10.1 PERCY STREET RESERVE ROUND 2 CONSULTATION OUTCOMES

File Number: IC22/199

PERCY STREET RESERVE

Engagement Report
Percy Street Reserve Upgrade – Round 2 Consultation 2022

Figure 2 – proposed fenced area for Option 1 is shown in red outline.

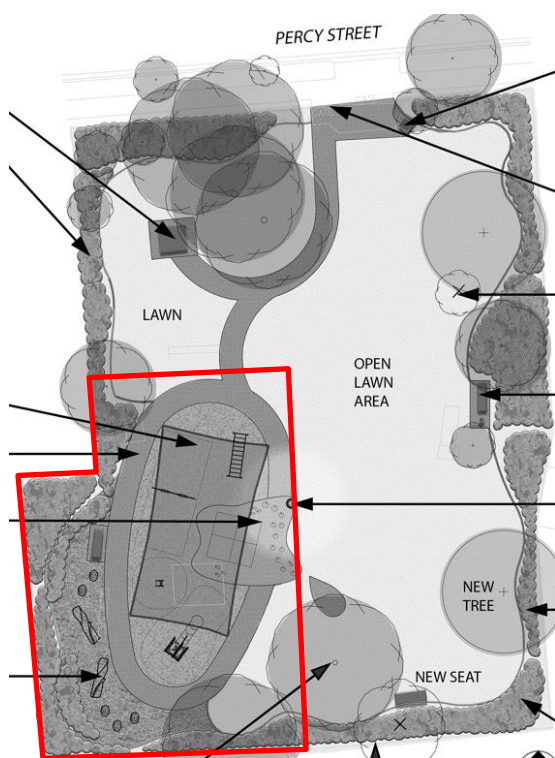
Separate the play area with a 1.2-metre-high fence and a gate with a child lock – see Figure 2 below. Install an additional picnic setting within the playspace area.

The fenced area can be used as a respite area away from dogs and can be used as a safe space by families within the nominated dog off-leash times. Council would need to allocate additional budget to the upgrade to allow for this fenced area to be implemented. This option has not been recommended by staff as it is beyond the budget capacity.

DRAFT CONCEPT PLAN

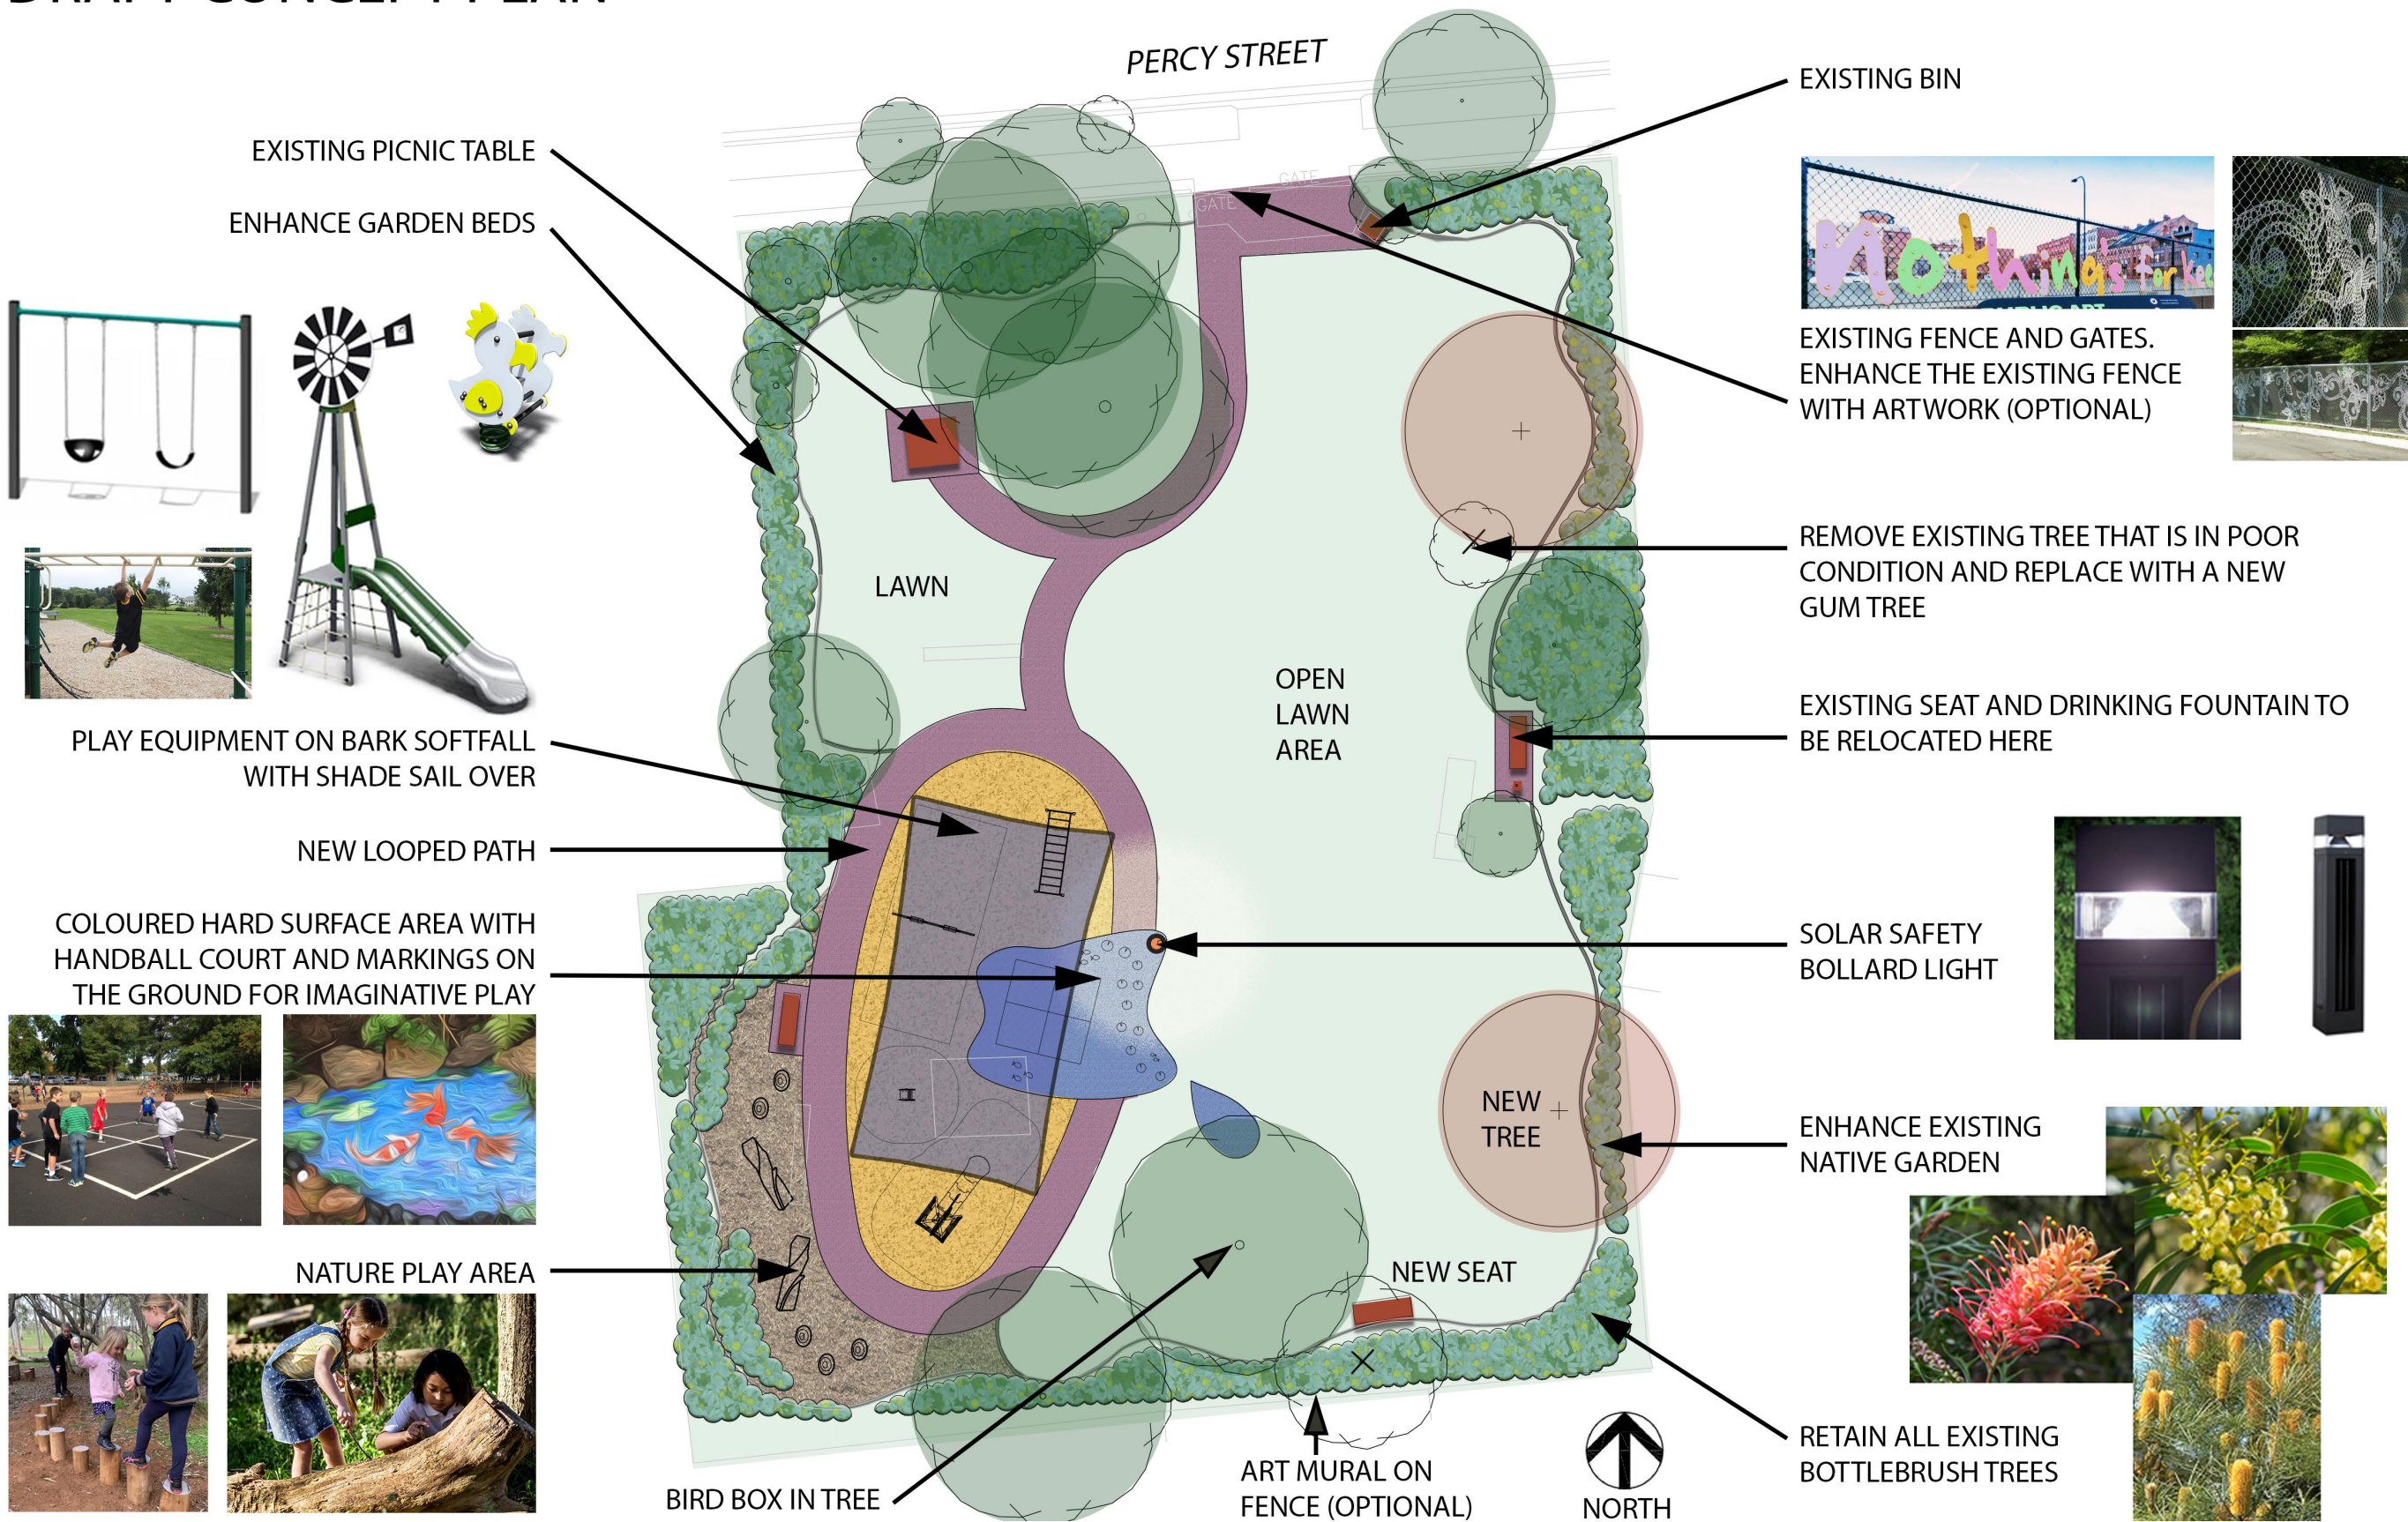
An Engagement Report was prepared and summarises the feedback received. The Engagement Report identified that, generally, there was a high level of support for the draft concept plan, with the following key themes of concern raised by park users:

- Conflict around dog behaviour.
- Need for more lighting.
- Anti-social behaviours in south-western corner, especially with the new children's play equipment proposed in that area.

The recommendations in the Engagement Report align with the key themes of concern listed above. These concerns will be addressed during the next stage of the project, the design development stage, by ensuring the light spill reaches south-west corner of the park and does not overspill into neighbouring properties, providing an appropriate solution for conflict around dog behaviour and refining the application of crime prevention principles to address antisocial behaviours.

Council staff recommend endorsement of the draft concept plan shown in Attachment 1, with a budget of \$215,000 as the final version.
